SERIAL: BSEP 02-0198

BRUNSWICK STEAM ELECTRIC PLANT, UNIT NOS. 1 AND 2
DOCKET NOS. 50-325 AND 50-324/LICENSE NOS. DPR-71 AND DPR-62
RESPONSE TO REQUEST FOR ADDITIONAL INFORMATION
REGARDING REQUEST FOR APPROVAL OF RELIEF REQUEST FOR
REACTOR PRESSURE VESSEL NOZZLE INNER RADIUS VOLUMETRIC
EXAMINATIONS (NRC TAC NOS. MB5854 AND MB5855)

Relief Request RR-29, Revision 1,
"RPV Nozzle Inner Radius Volumetric Examinations"

Relief Request RR-30, Revision 1,
"RPV Nozzle Inner Radius Volumetric Examinations"

Figure 1
Typical Cross Section of BWR Nozzle with Internal Piping

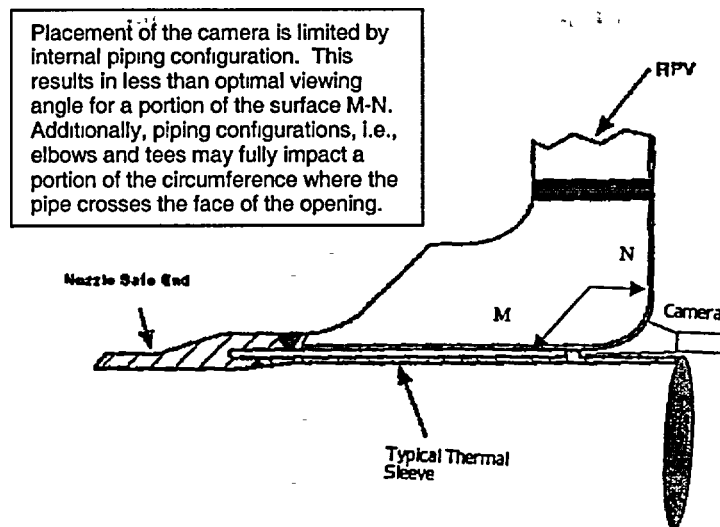
- Visual examination of the inner radius region of the specified nozzles is limited because the reactor internal piping configuration prevents placement of the camera in all positions necessary to examine surface M-N over the full circumference (i.e., see Figure 1 below).

The specific nozzle limitations and estimated coverage are as follows:

Nozzle Type/Number	Limitation	Estimated Coverage
Core Spray(2 nozzles)	Thermal Sleeve and Sparger	40%
Reactor Recirculation Inlet (10 nozzles)	Thermal Sleeve/Jet Pump Riser	50%
Jet Pump Instrumentation(2 nozzles)	Instrumentation Lines	60%
